# UNITED STATES PATENT AND TRADEMARK OFFICE

APPLICATION NO.	FILING DATE	FIRST NAMED INVENTOR	ATTORNEY DOCKET NO.	CONFIRMATION NO.
10/780,512	02/17/2004	Tai-Chun Huang	TS03-461	1383
42717	7590	04/06/2005	EXAMINER	
HAYNES AND BOONE, LLP 901 MAIN STREET, SUITE 3100 DALLAS, TX 75202			CHU, CHRIS C	
			ART UNIT	PAPER NUMBER
			2815

**Office Action Summary**

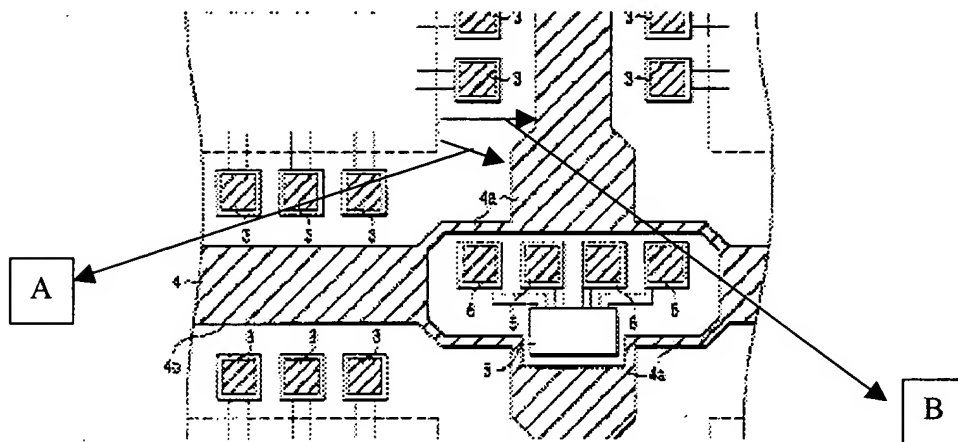
Regarding claim 16, Tsuji et al. discloses in Figure and column 2, lines 45 – 67 a semiconductor device (1; column 2, line 46) comprising:

- semiconductor device structures (any structures inside of the element 4) formed in and on a substrate; and
- a seal ring (4; column 1, line 58 – 60 and Figure show corners and sides of four chips that are separated by the lines 4. Thus, the lines 4 that cover the every corners and

- sides of a single chip's board lines read as a continuous seal ring.) enclosing said semiconductor device structures forming a single die (2; column 2, line 51),
- wherein a first distance (A) between said semiconductor device structures and a corner portion of said seal ring is smaller than a second distance (B) between said semiconductor device structures and an edge portion of said seal ring (see Figure below).

Regarding claim 21, Tsuji et al. discloses in Figure said corner portion (4a; column 2, line 54) of said seal ring (4) having a first width and wherein said edge portion (4b; column 2, line

55) of said seal ring has a second width wherein said first width is wider than said second width (see Figure and column 2, lines 54 – 56).

Regarding claim 22, Tsuji et al. discloses in Figure said first width being “about” 1.5 times said second width or greater (column 2, lines 61 – 63).

Regarding claim 23, Tsuji et al. discloses in Figure said first width of said seal ring covering a portion of said corner portion of said seal ring (see the Figure).

Regarding claim 25, Tsuji et al. discloses in Figure one or more slots or holes (at the area where the elements 5 and 6 are formed) being formed in said corner portion (4a) of said seal ring (4).
